Number	Description
1	Revised Table of Contents; Revised NTB No. 5425; Add NTB No. 5511; Revised Bid Items; Revised Progress Schedule; Revised or Added Plan Sheet Nos. 2-6; Amendment EBS Download Required.

**PROJECT: MP-1015-70(015) / 305423301 - Tippah**

Mill and Overlay approximately 5 miles of SR 15 from End 3-lane in Ripley to CR 407, known as State Project No. MP-1015-70(015) / 305423301 in Tippah County.

# ADDENDUM

MISSISSIPPI DEPARTMENT OF TRANSPORTATION			
DETAILED INDEX			
COUNTY: TIPPAAH	WORKING NUMBER	DI-1	SHEET NUMBER
PROJ. NUM.: MP-1015-70(015)			
FILENAME: SR15_TIPPAH.DGN	DESIGN TEAM	CHECKED	DATE

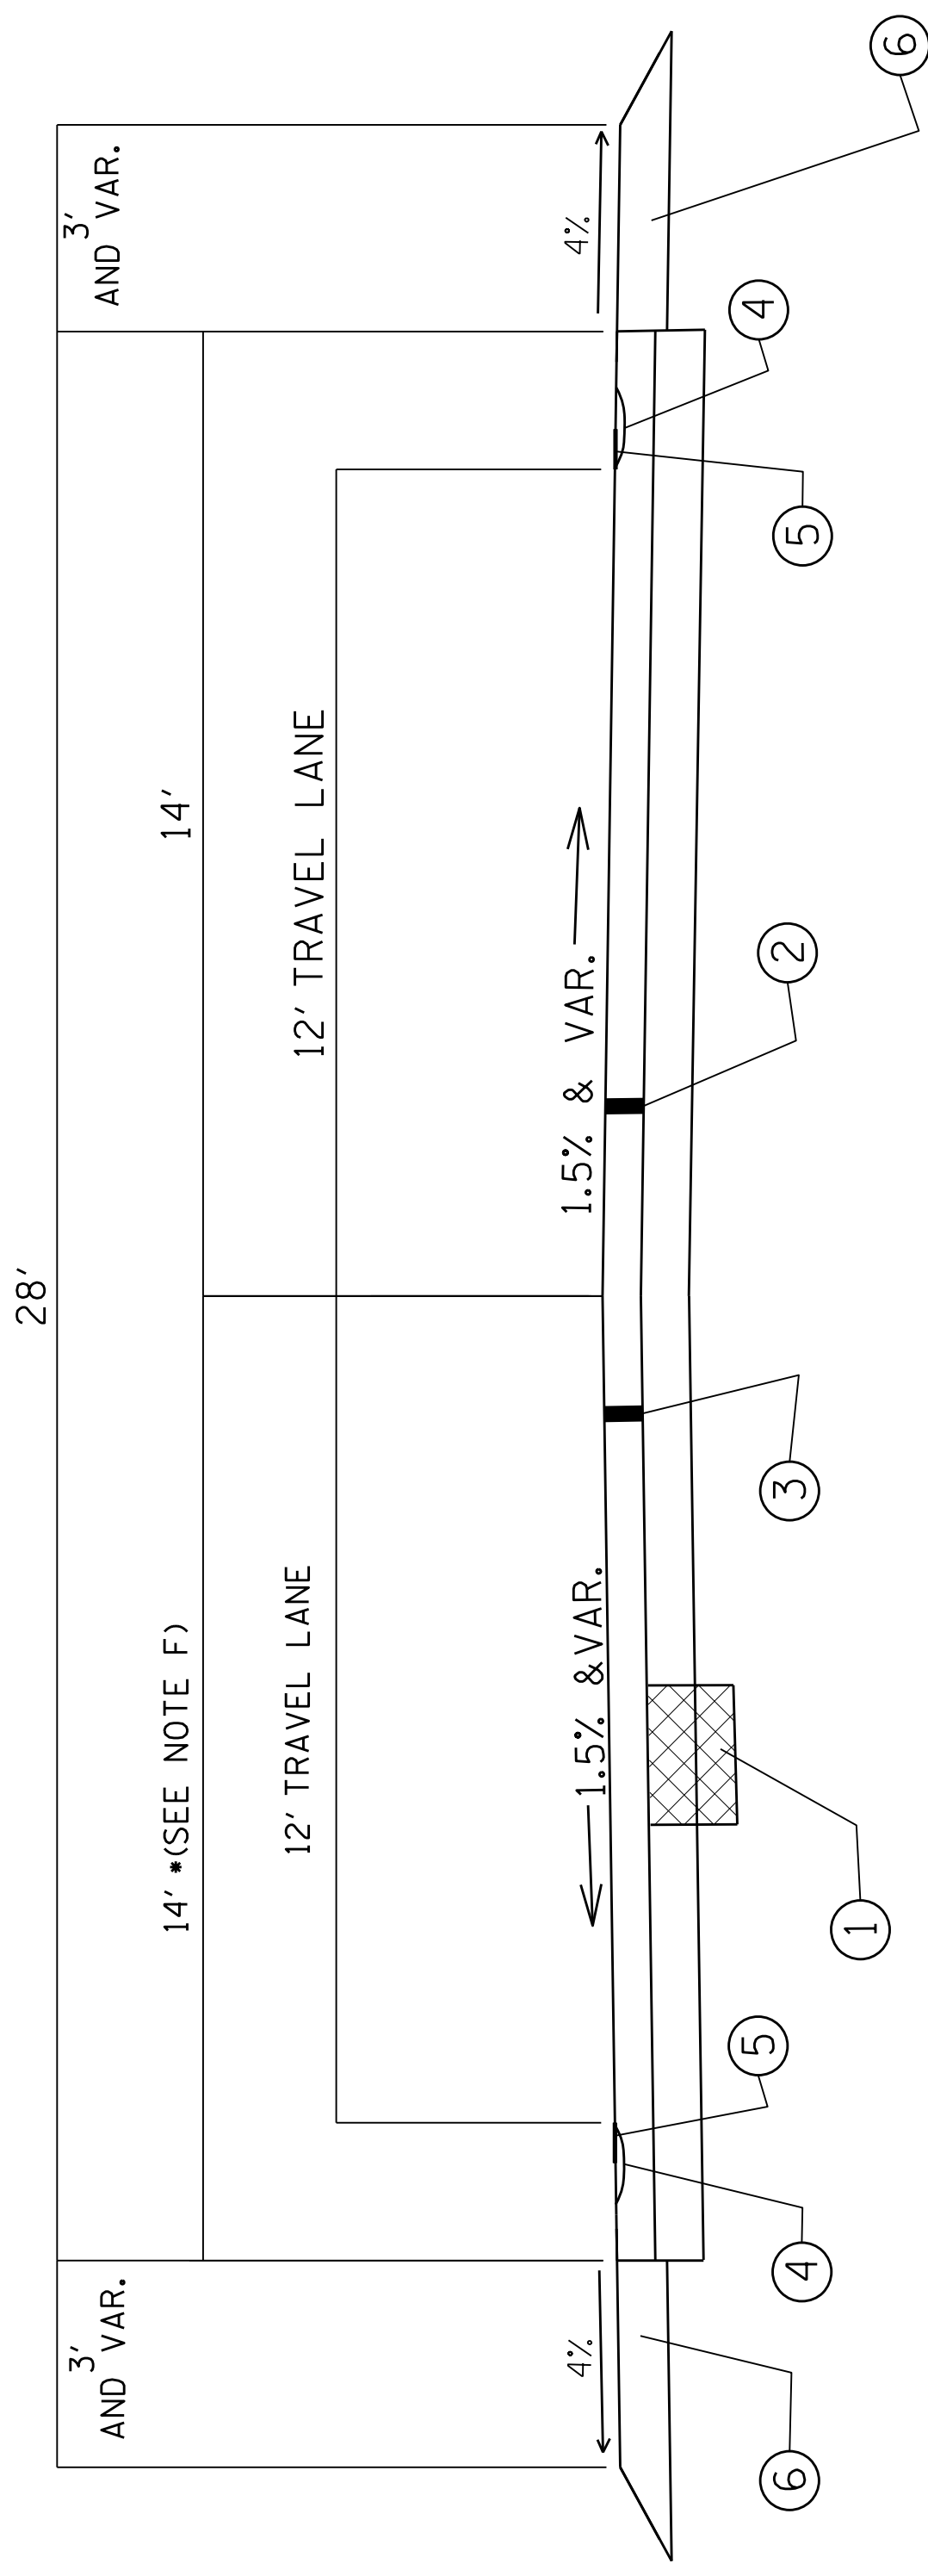
DATE	DELETED MILL AND FILL NOTE	REVISION	BY
4/17/15			MJC

TYPICAL OVERLAY SECTION  
MAINLINE

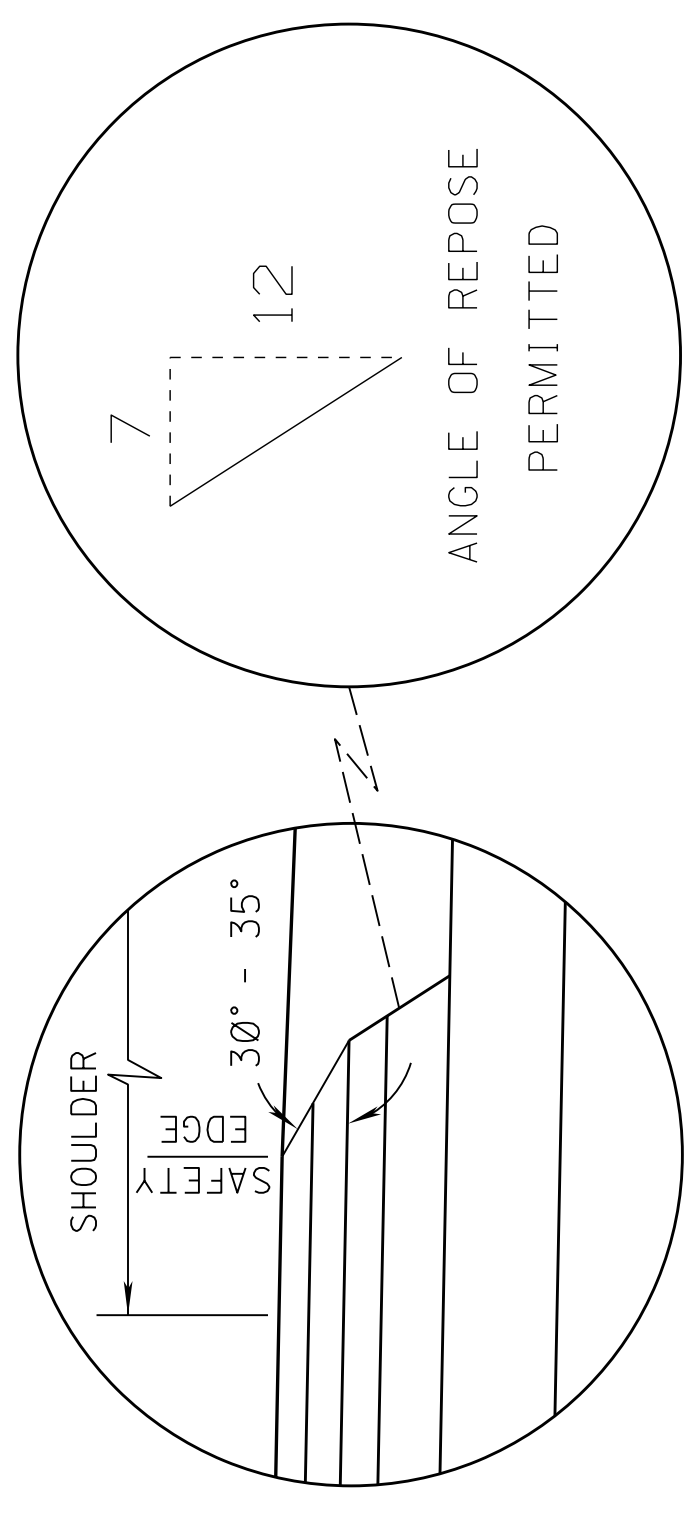
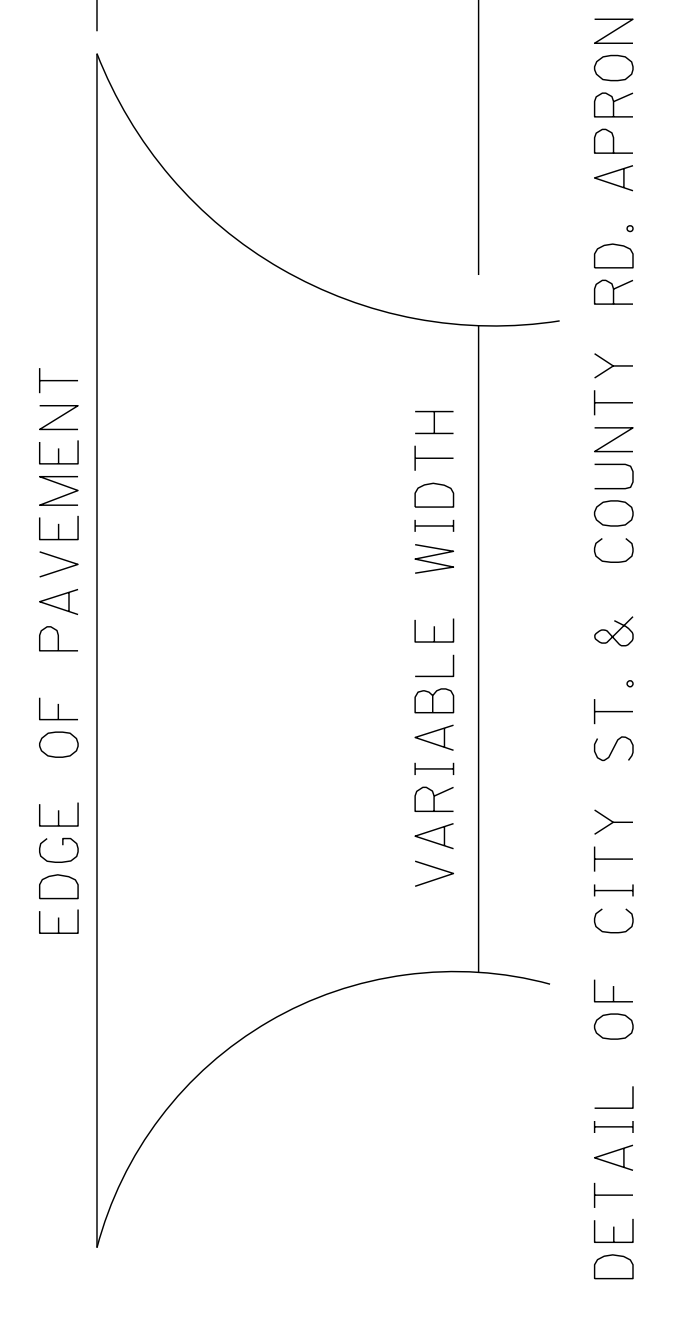
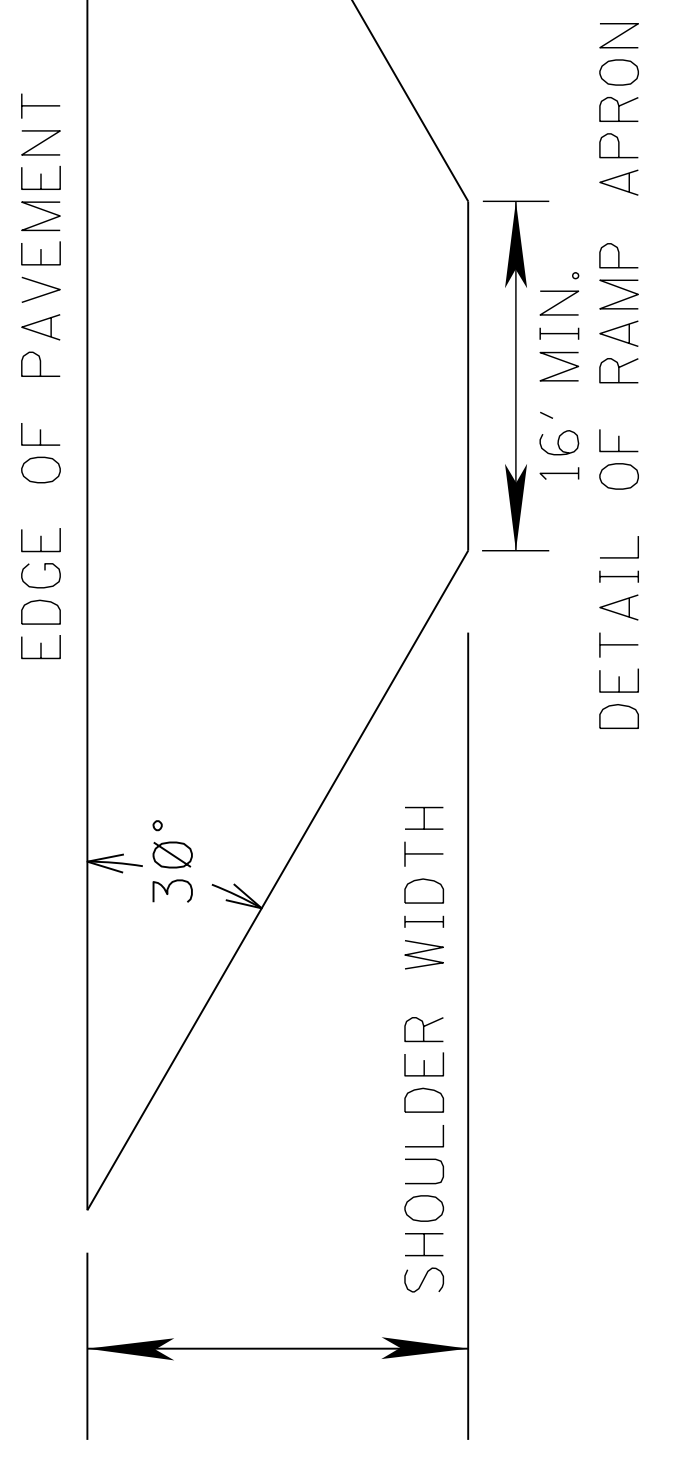
4/17/15	DELETED MILL AND FILL NOTE	BY	MJC
	REVISION
